# UNITED STATES PATENT AND TRADEMARK OFFICE

APPLICATION NO.	FILING DATE	FIRST NAMED INVENTOR	ATTORNEY DOCKET NO.	CONFIRMATION NO.
10/721,035	11/21/2003	Helen T. Pham	PHA.001.P	5030

# Office Action Summary

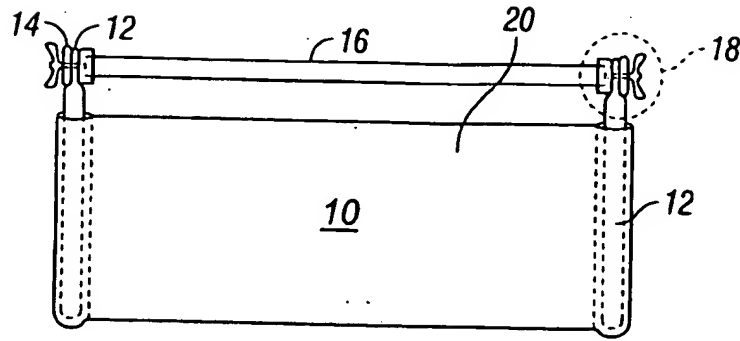
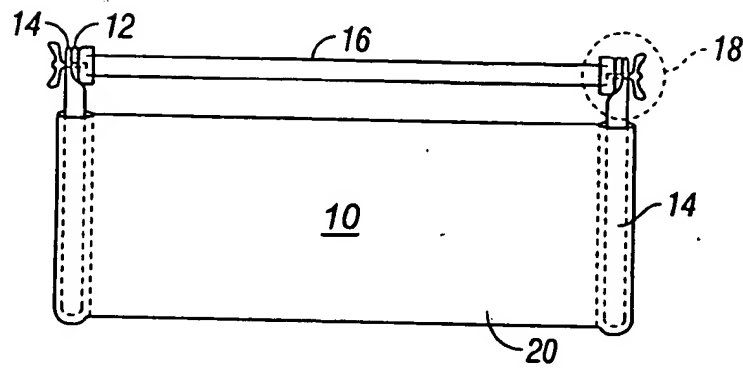
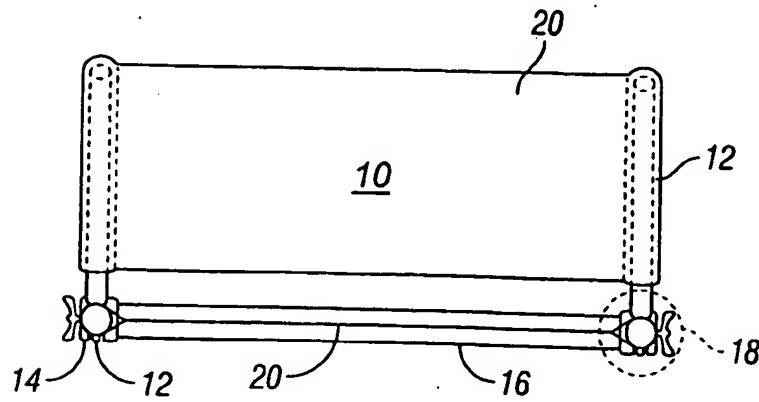
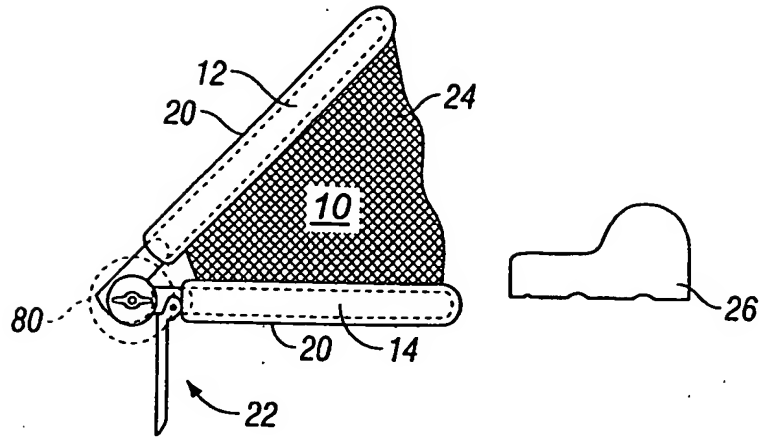
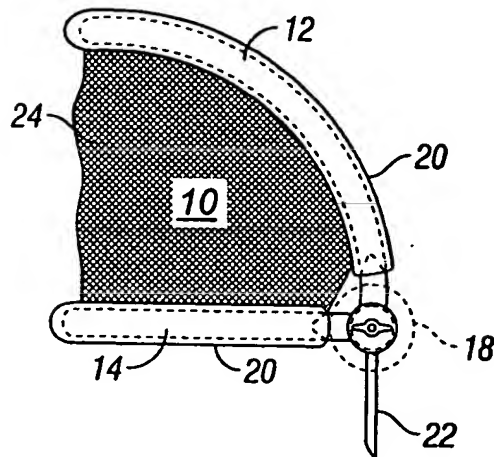
2. The replacement drawing sheets filed 03/28/05 are accepted as they overcome the objections set forth in sections 2 and 3 of the last Office action. However, the drawings remain objected to under 37 CFR 1.83(a). The drawings must show every feature of the invention specified in the claims. Therefore, the head and neck rest removably affixed to the device must be shown or the feature(s) canceled from the claim(s). No new matter should be entered. Applicant argues that Figure 1D shows this feature. The examiner disagrees. Figure 1D merely shows a head rest adjacent the sunshield device. There is nothing illustrating any removable affixing.

3. The disclosure is objected to because of the following informalities: The "Description of the Figures" reference "Figure 1". There is no Figure 1. The examiner suggests applicant replace "Figure 1: is a diagrammatic representation" with - - Figures 1A-1E are diagrammatic representations - -.
